**Phase 2 Work Plan Addendum**  
for  
**Naval Weapons  
Industrial Reserve Plant**  
Bethpage, New York

**Northern Division  
Naval Facilities Engineering Command**  
Contract Number N62472-90-D-1298  
Contract Task Order 0089

**FOR THE MEMBERS OF THE TECHNICAL REVIEW COMMITTEE (TRC) FOR  
INSTALLATION RESTORATION PROGRAM AT NAVAL WEAPONS INDUSTRIAL  
RESERVE PLANT (NWIRP) BETHPAGE, NEW YORK**

R-49-11-92-6

**FIGURE 4-3**

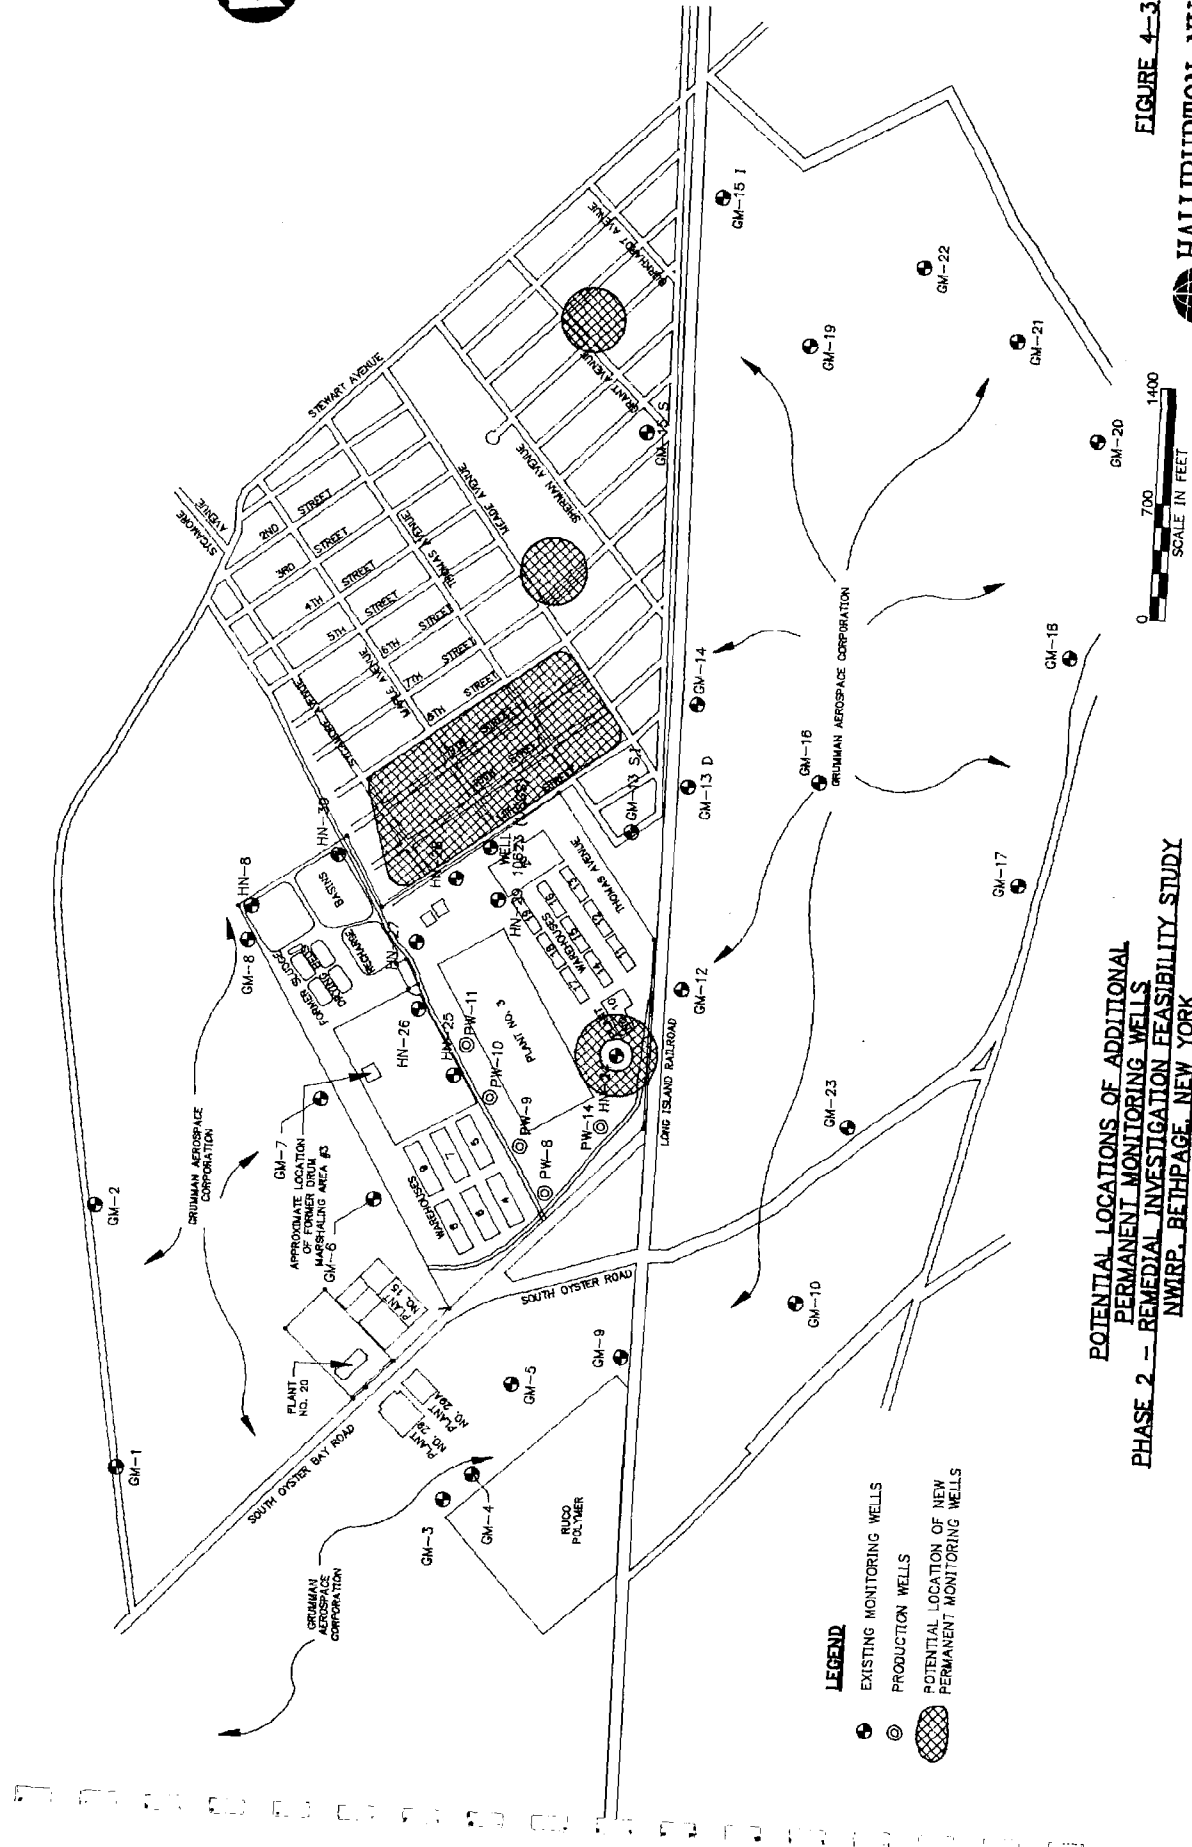
6. Comment: Page 4-5: Include a separate graphic depicting possible locations of permanent monitoring well locations both on-site and off-site. State in the narrative on Page 4-5 that these locations are tentative. Also, state the approximate direction and distance for the on-site wells from HN-24I.

Response: Figure 4-3 will be added to the report to indicate tentative locations for the new permanent monitoring wells. Also, the location of the new wells near HN-24I and the approximate distance of 100 to 300 feet will be referenced.
